253 GOLDHURST TERRACE

**Our ref: 2023/2714/PRE
Contact: Enya Fogarty
Direct line: 020 7974 8964
Email: Enya.Fogarty@camden.gov.uk**

Re: 253 Goldhurst Terrace, London NW6 3EP

Development Description

REAR ELEVATION

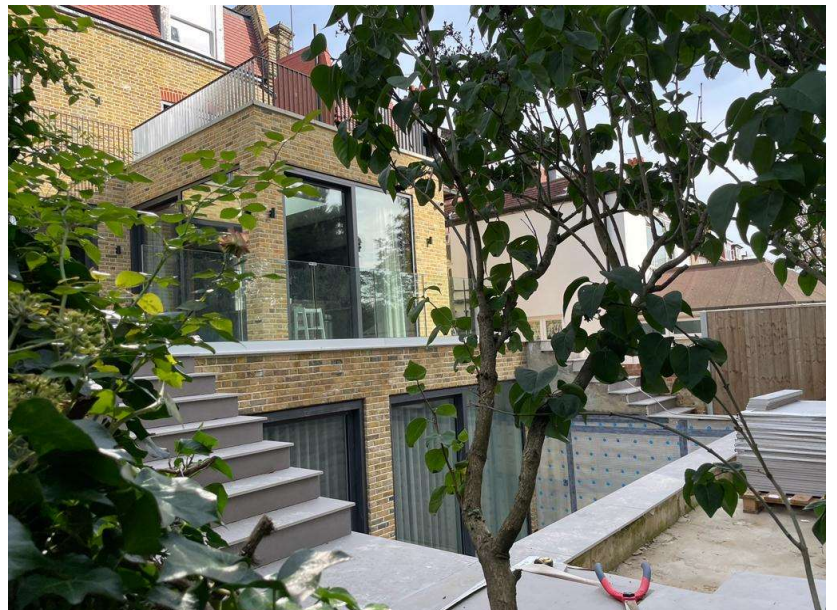
Unfortunately, the view of the rear on Google Maps is not very clear, and the 2D drawings of the rear facade in context are not as representative as the real view.

As you can see, the style of the two rear facades is characterized by a significant presence of windows and by the presence of glass balustrade at the ground floor level. Following your advice, we reduced the transparent area, widening the brick columns on the side of the windows (please refer to the attached updated rear elevation).

Furthermore, the proposed glass balustrade on the rear of the property would be an integral part to the project as it would maintain continuity with the neighbouring houses without adversely affecting the overall view of the rear facade. Taking into consideration the two immediately neighbouring properties, could the glass balustrade as currently presented in the project be acceptable?

Thank you for your email. Regarding the glass balustrade and replacement windows with double glazing. If there is clear recent examples of where permission has been granted for similar development then this would be taken into consideration and should be considered acceptable as precedent has been set.

Ref. 2022/5014/P 253 Goldhurst Terrace.

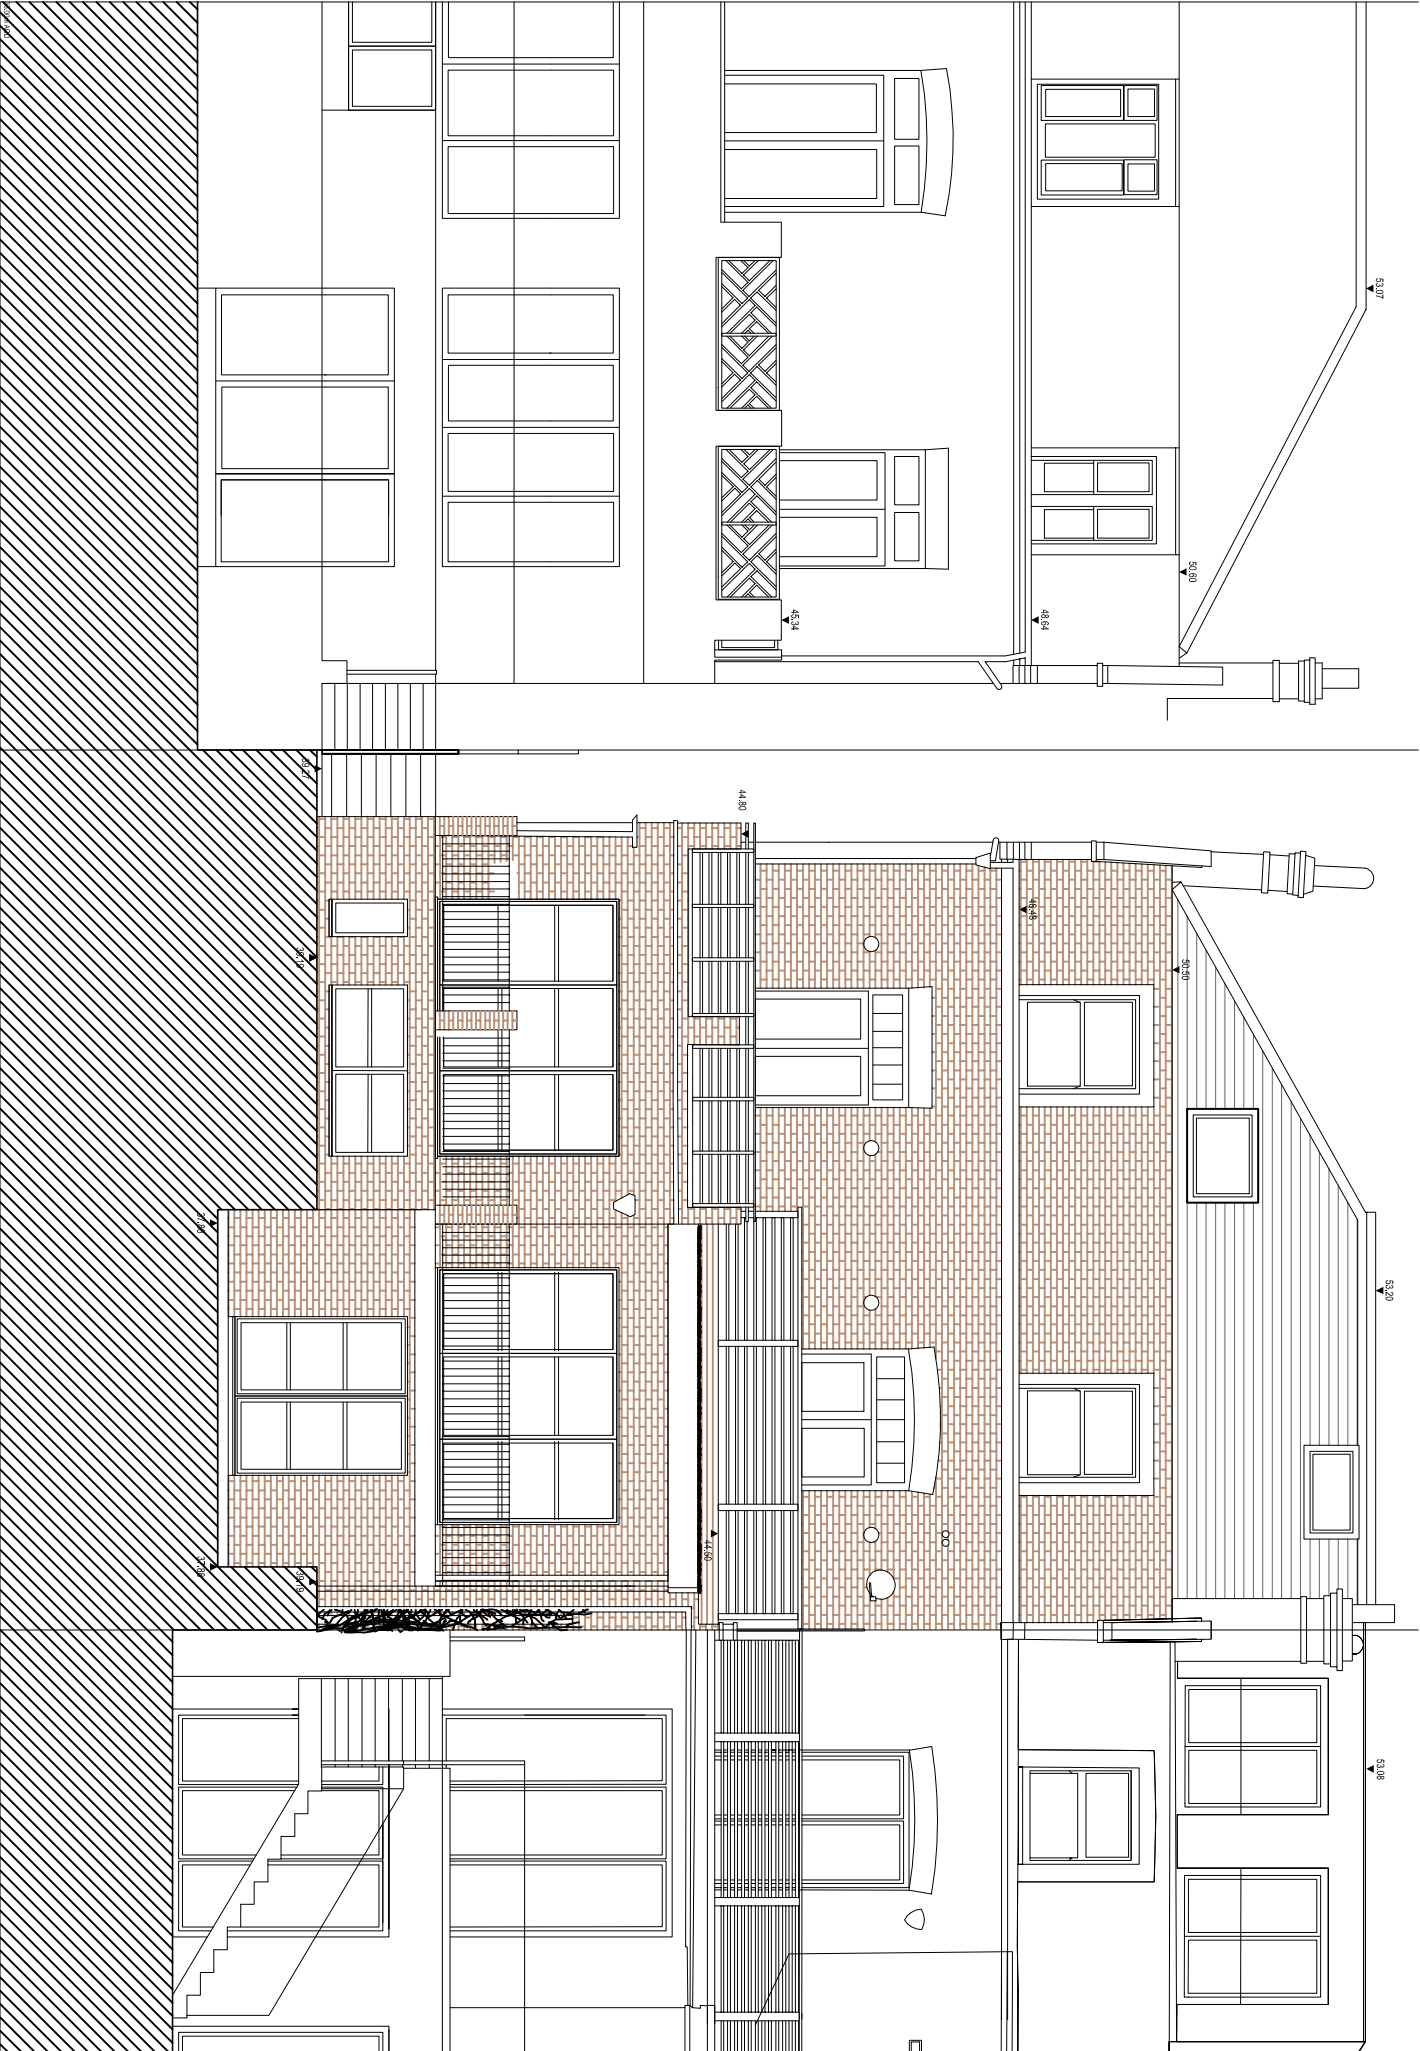
The original application involved to the same elements but had a different design.

Can we submit the pre-application drawings as a replacement for the submitted drawings?

Regarding the current application- 2022/5014/P are ye proceeding with this application or are submitting a new application so I am clear ?

I would advise that you withdraw the current application and resubmit with a new application. As the description would have changed new site notices would have to be erected.

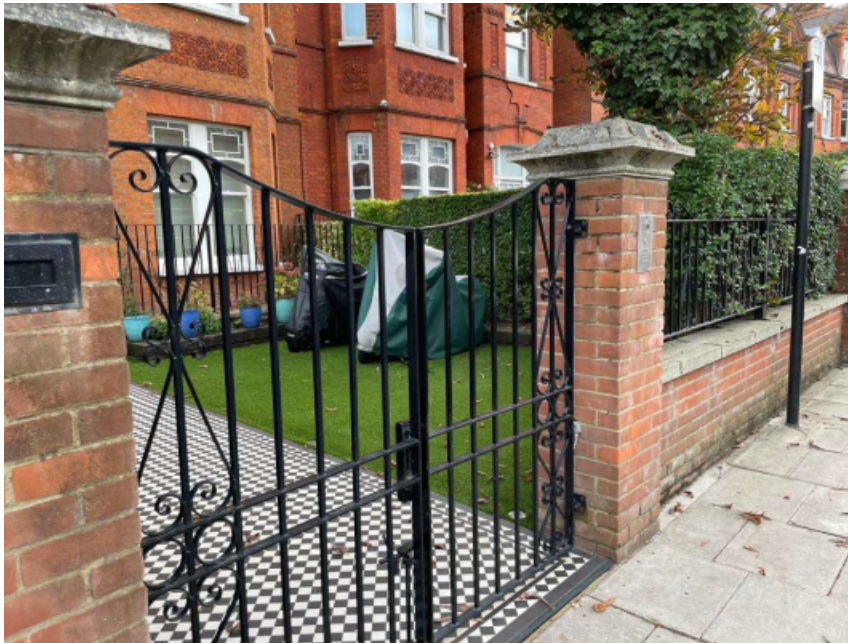
The proposed boundary treatment below I would consider acceptable. Please ensure there is hedging behind the iron railings as introducing soft landscaping softens the boundary treatment and also adds a sense of security to the applicants.
